Project number: 20004
Prepared by: Helen Jenkins/Andy Roberts
Subject: Comments on proposed development at land off Capel Street, Capel-le-Ferne
Date: 15th January 2020 **File no:** 20004.D1a

1.1.1 This technical note has been produced on behalf of Capel-le-Ferne Parish Council to comment on the proposals for 34 residential dwellings off Capel Street (between Nos. 107 to 127). Lime Transport's experience and the qualifications of this report's authors are included at the back of the report.

Figure 1 Extract from Amended Proposed Highway Works drawing

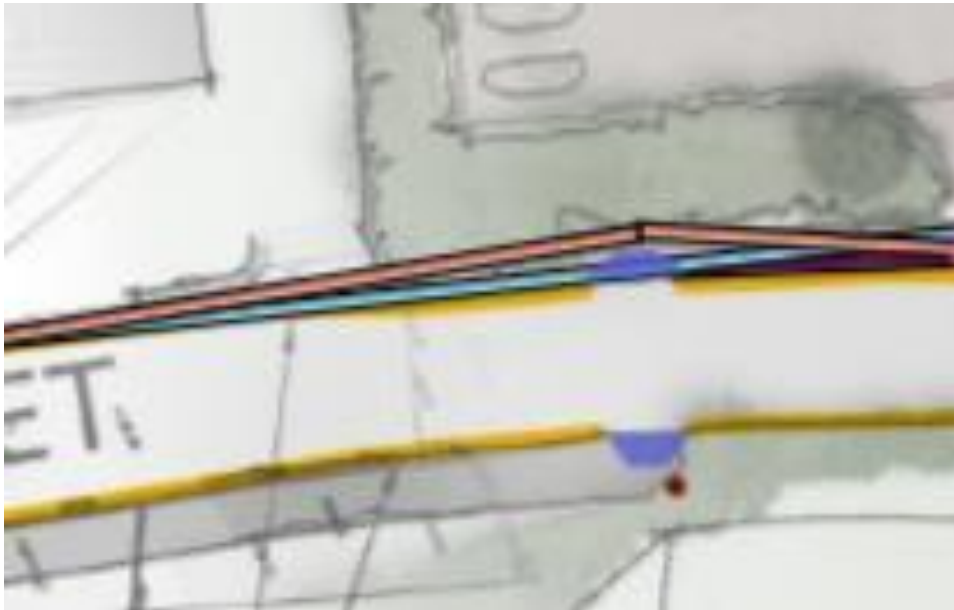
- 2.9.2 The submitted drawing is not acceptable as:
- It does not show a number of existing accesses to private driveways.
 - It is not possible to determine how the carriageway of Capel Street is being widened from 4.2-5.1m to 5.5m. There is no key to show the extent of existing carriageway or the proposed widening and whether this is to the eastern or western side of the existing carriageway.

- The width of the visibility splay lines obstructs the base plan and makes assessment of the impact on third party land difficult. An extract (Figure 1) showing pedestrian visibility splays appearing to cross private land (No. 107) is included below.

Drawing No
20004.TOPO.101.02

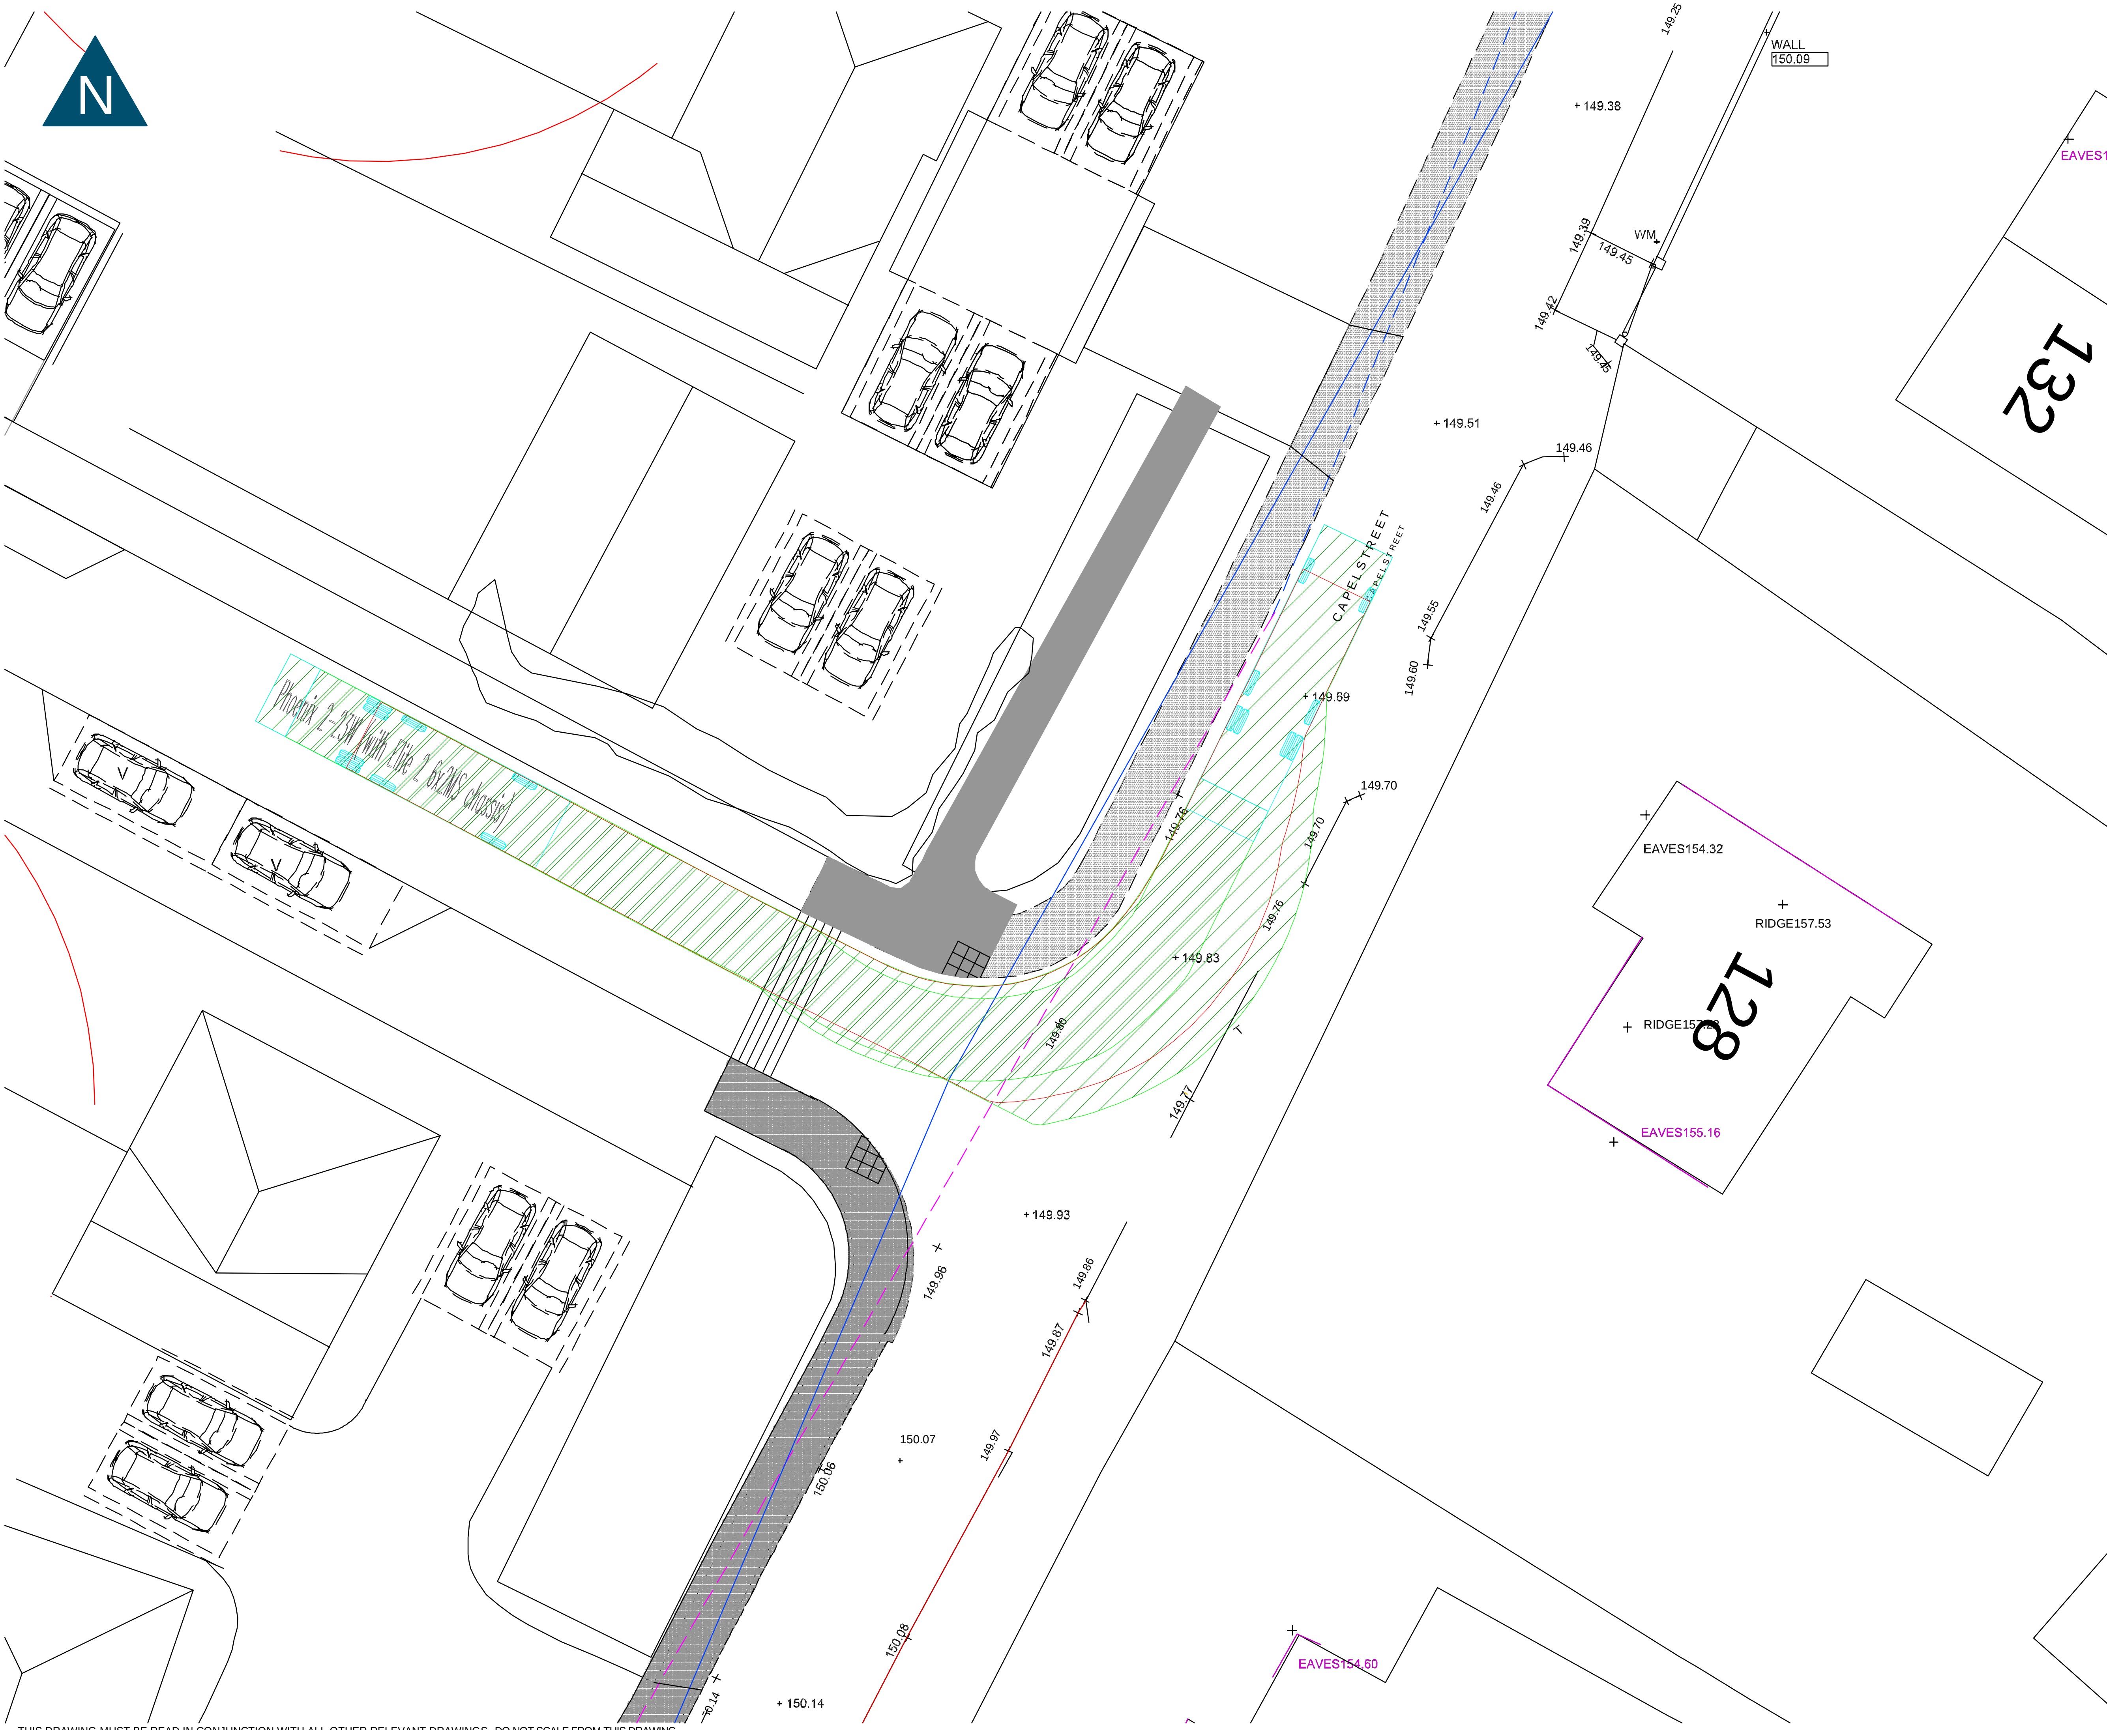
- There is no swept-path analysis to demonstrate that a large refuse vehicle can egress the site without over-sweeping the centre-line of Capel Street in to the path of an oncoming vehicle. Again, swept-path analysis has been carried out as part of this review, which demonstrates that the body of the vehicle will over-sweep the entire carriageway and even the verge on the eastern side of Capel Street (see drawing 20004.TOPO.101.02).

Drawing No
20004.TOPO.101.03

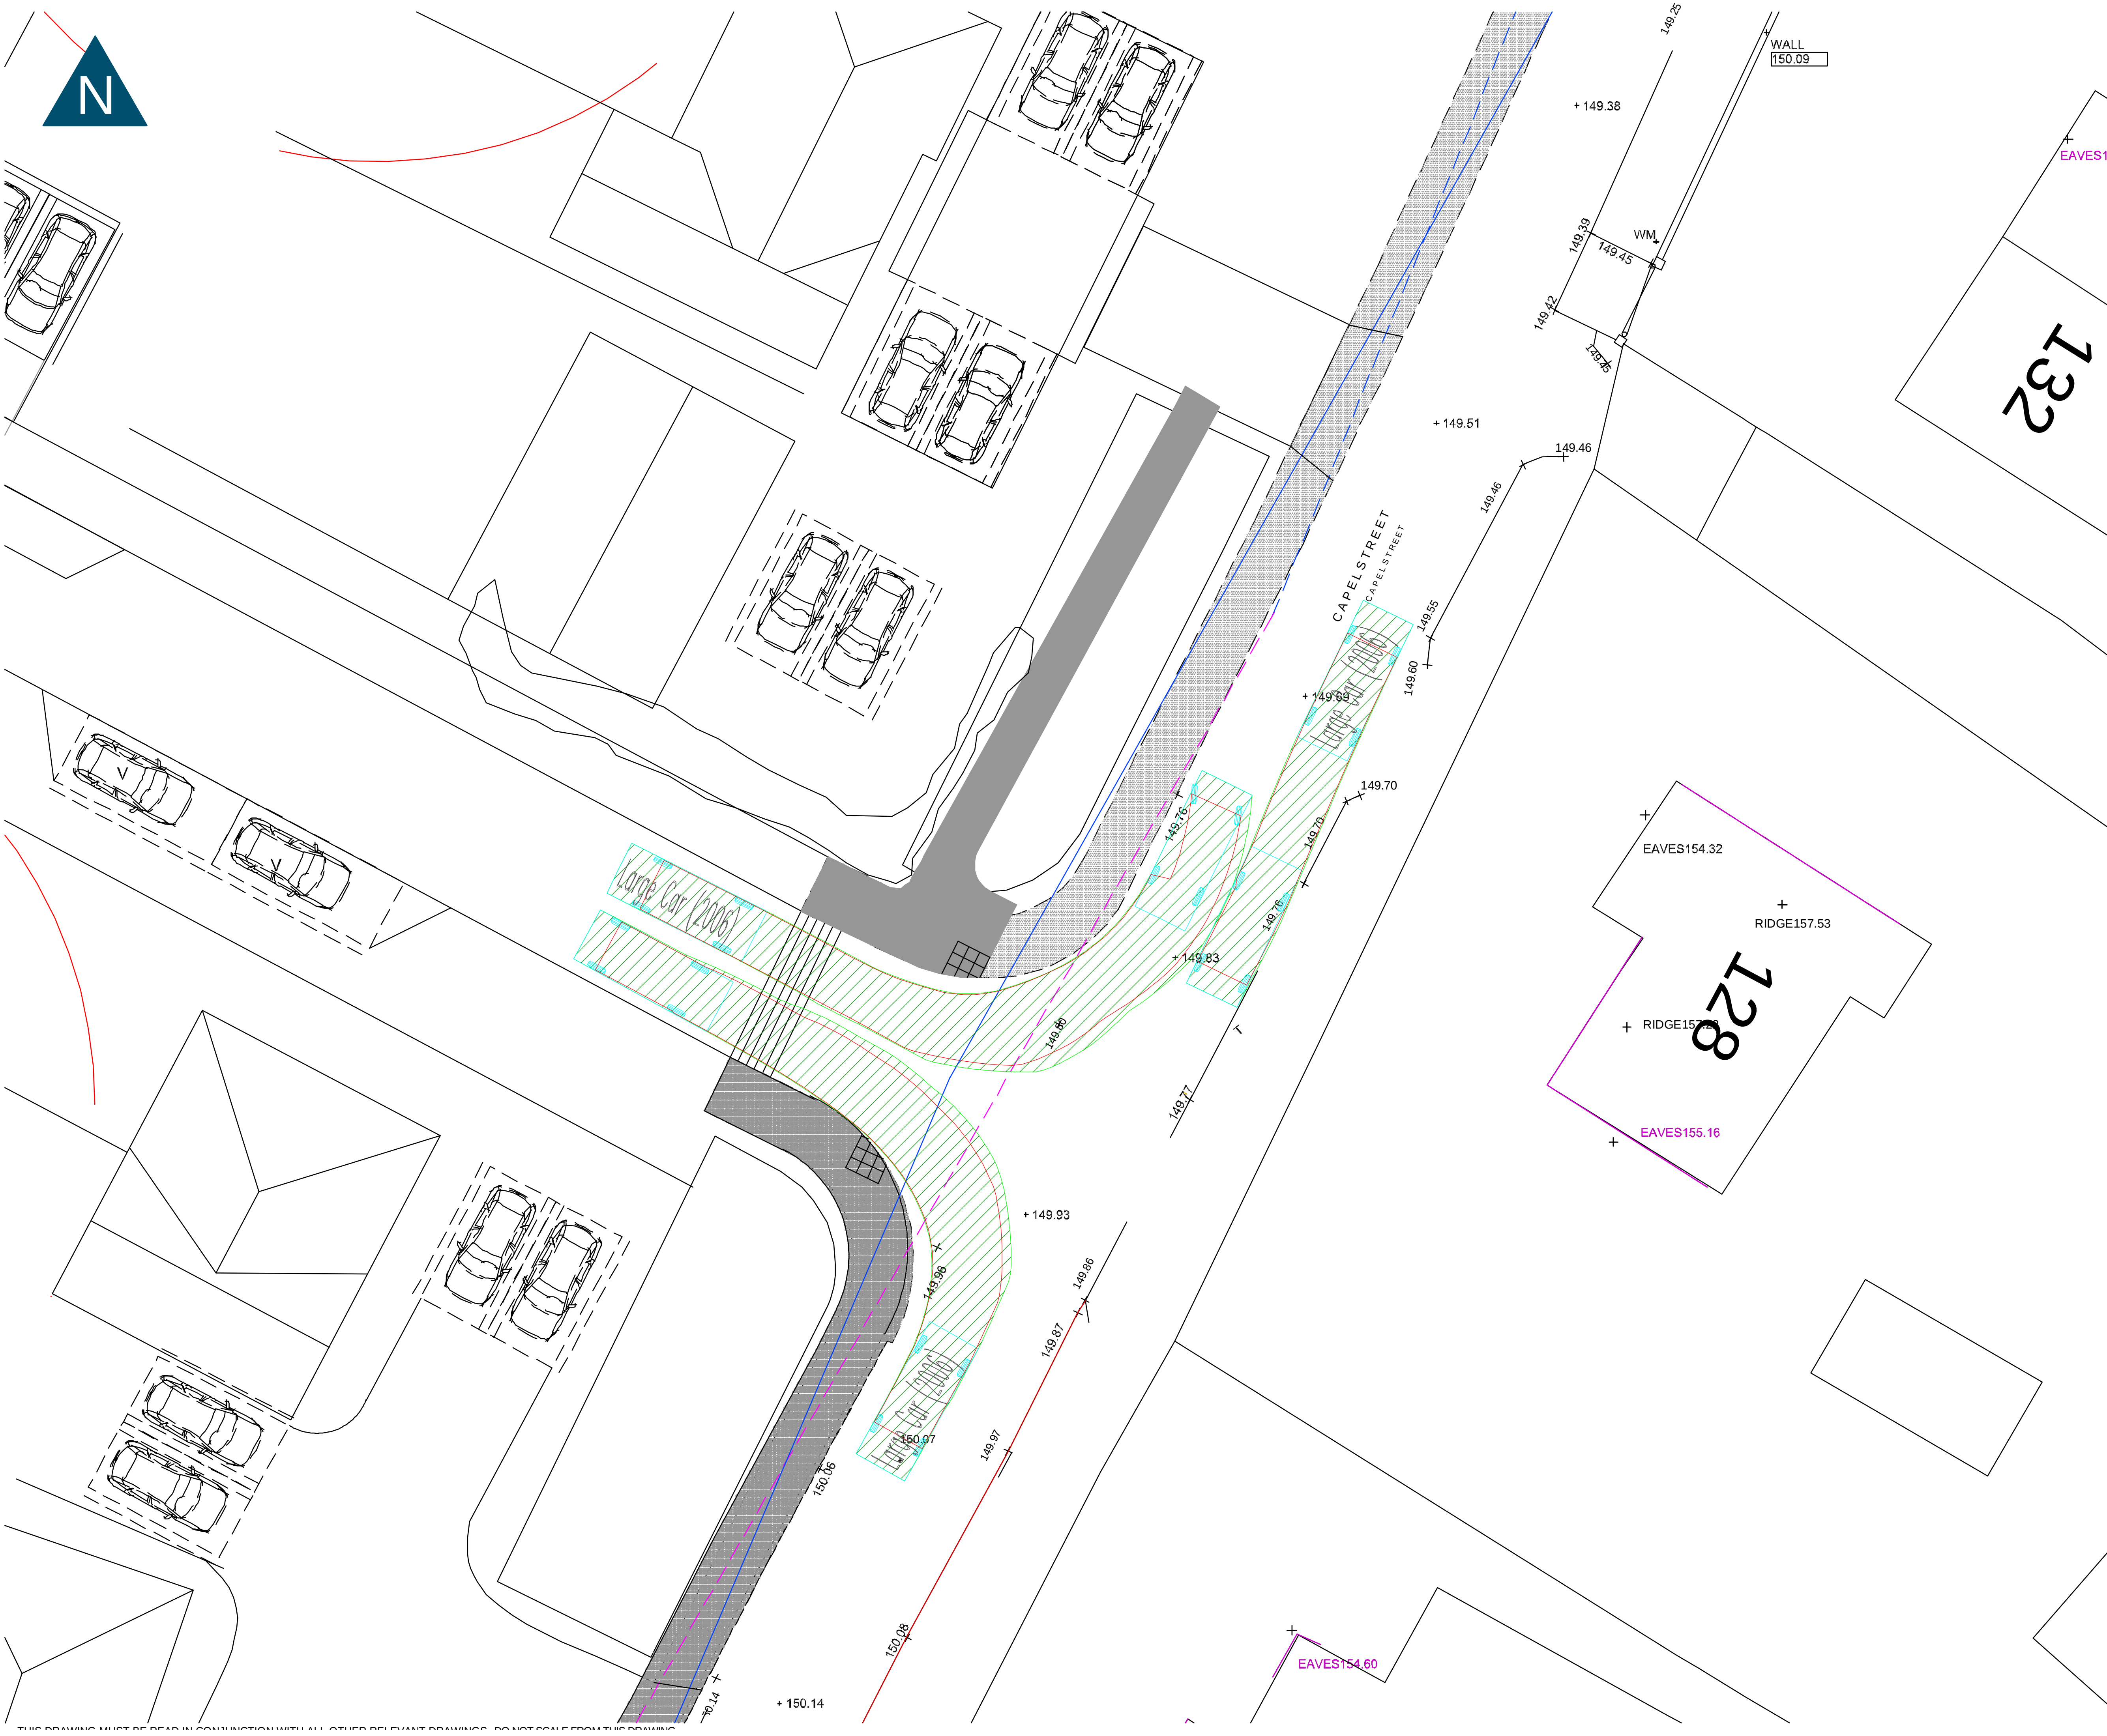
- There is no swept-path analysis to demonstrate that a large car can egress the site without over-sweeping the centre-line of Capel Street into the path of an oncoming vehicle. As part of this review, swept-path analysis has been undertaken. This shows that a large car turning left out of the site, will cross the centre-line of Capel Street potentially into the path of an on-coming vehicle (see drawing 20004.TOPO.101.03).
